PLAN REVIEW SHEET

Telephone: 704-353-0018 Petition: 2013-008

> CPCC Email: bhorton@charlottenc.gov

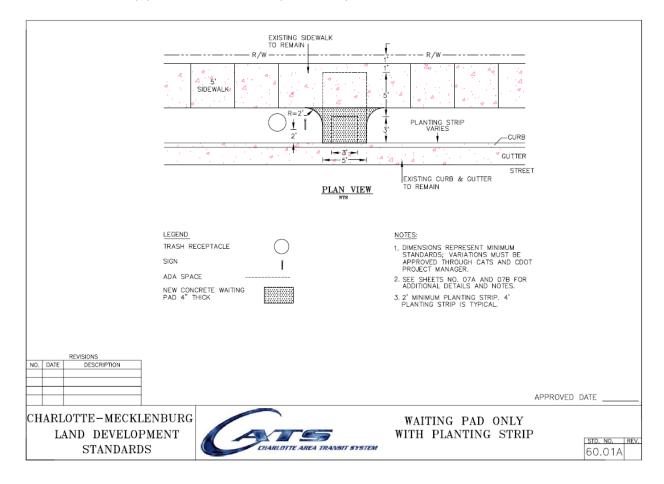
We request that the Petitioner provide a waiting pad for the existing bus stop along Alleghany Street. Given the proposed use and increased number of students, the number of bus passengers using this stop is expected to significantly increase.

The size and specification of the concrete waiting pad at the bus stop would be located between the existing curb and the existing sidewalk and be 5 feet in width. Pad must be flush with sidewalk and level within 2% when measured perpendicular to street for compliance with the ADA. Below is an image of the standard (CLDSM – 60.01A) waiting pad.
